Service Bulletin No. 421

<i>MODEL</i> D / J Series	<i>TYPE</i> Field Change Program	<i>SECTION/GROUP</i> 1-Front Axle	<i>DATE</i>
<i>SUBJECT</i> MERITOR TIE ROD END CASTELLATED NUT			
<i>CONDITIONS</i>

Ref. Meritor NHTSA Recall No.:15E-012

Checking the Tie Rod End Castle Nut Torque on Meritor Bus and Coach Non-Drive Steer and Tag Axles

Figure 2

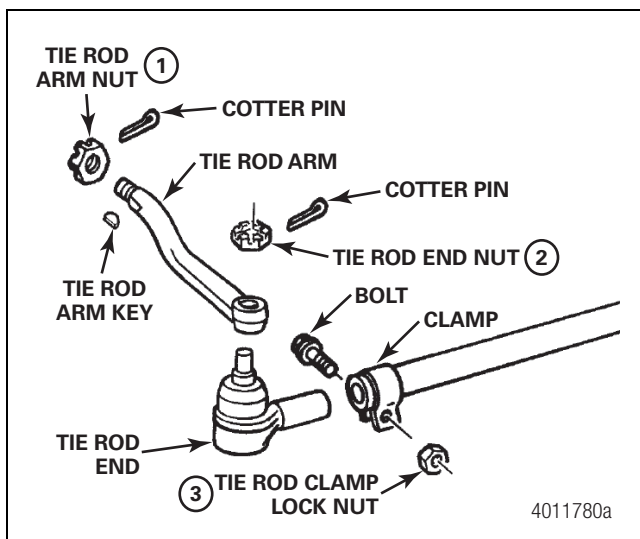
1. Wear safe eye protection. Park the vehicle on a level surface.
2. Place blocks under the wheels not being serviced to keep the vehicle from moving.
3. Raise the vehicle so that the wheels you will service are off the ground. Support the vehicle with safety stands.
4. Remove the cotter pin that secures the tie rod end castle nut to the tie rod arm. Figure 2.

Item	Description	Size	Torque Range in Lb-Ft (N•m)
1	Tie Rod Arm Nut	1.250"-12	775-1450 (1051-1965)
2	Tie Rod End Nut	0.875"-14	160-300 (217-407)
3	Tie Rod Clamp Lock Nut	0.750"-10	155-175 (210-237)

Figure 3

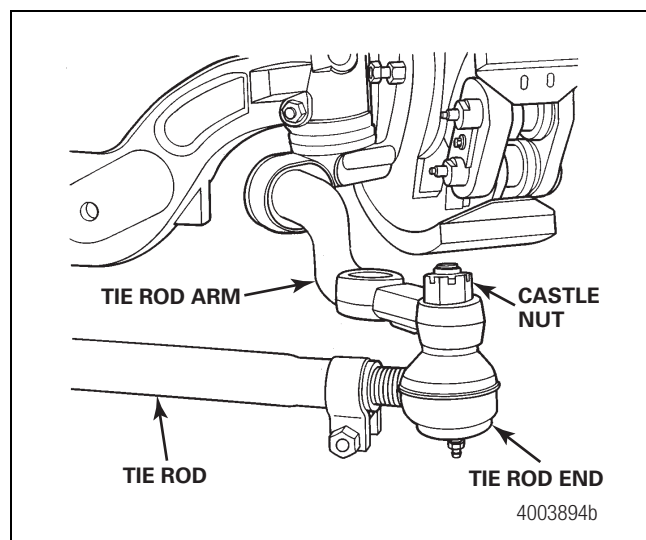
5. Place a calibrated torque wrench on the tie rod end castle nut.
6. As a verification check to ensure the castle nuts are not hand loose or below 25 lb-ft (34 N•m), set the torque wrench to 25 lb-ft (34 N•m). Rotate the tie rod end castle nut in a clockwise direction and note if the nut turns before reaching the set torque. Figure 3.

- **If the tie rod end castle nut does not rotate prior to reaching 25 lb-ft (34 N•m):** Proceed to Step 7.
- **If the tie rod end castle nut rotates prior to reaching 25 lb-ft (34 N•m):** Remove the castle nut and tap the tie rod arm with a brass or leather mallet to check the taper lock. Note it is not necessary to strike the tie rod arm hard to perform this check. On some axles, the ball stud may be mounted above the tie rod arm. In such case, lift up on the tie rod end to verify the taper lock. The taper lock should not separate when the tie rod arm is tapped. The two parts should be locked together.
 - **If the joint separates easily when tapped:** Proceed to the Inspect the Tie Rod Stud and Tie Rod Arm Bore, If Required procedure in this technical bulletin.
 - **If the joint does not separate when tapped:** Proceed to Step 7.

7. Install the tie rod castle nut and tighten to 160 lb-ft (217 N•m). 
8. If the hole for the cotter pin is not aligned, tighten the castle nut to align the next available hole in the nut. Do not loosen the nut to align the cotter pin hole. Install a new cotter pin, part number K-2412 (1/8" x 1.5").
9. The torque check of the castle nut is complete. Repeat the procedure on the opposite side of the vehicle.
